Technical Service Bulletin

94 Daytime running light (DRL) inoperative (DTC 02895 or 02897)

94 15 72 2032184/6 August 19, 2015. Supersedes Technical Service Bulletin Group 94 number 15-68 dated June 29, 2015 for reasons listed below.

Model(s)	Year	VIN Range	Vehicle-Specific Equipment
Q5	2013 - 2016	All	Not Applicable

Figure 3. Current (left) and early (right) style LED DRL units.

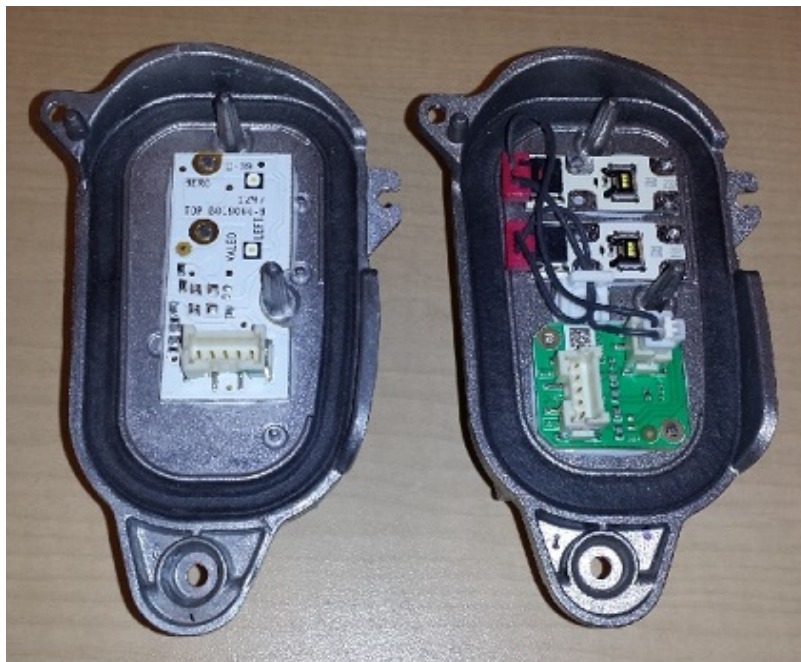
As of March 12th, 2013 production, the LED unit with heat sink has been updated (Figure 3). If a failure occurs, these parts do *not* need to be replaced in pairs.

6. The appearance of the replacement part for the LED DRL has changed, but functionality is the same. If an LED DRL needs to be replaced, they do not need to be replaced as a pair.
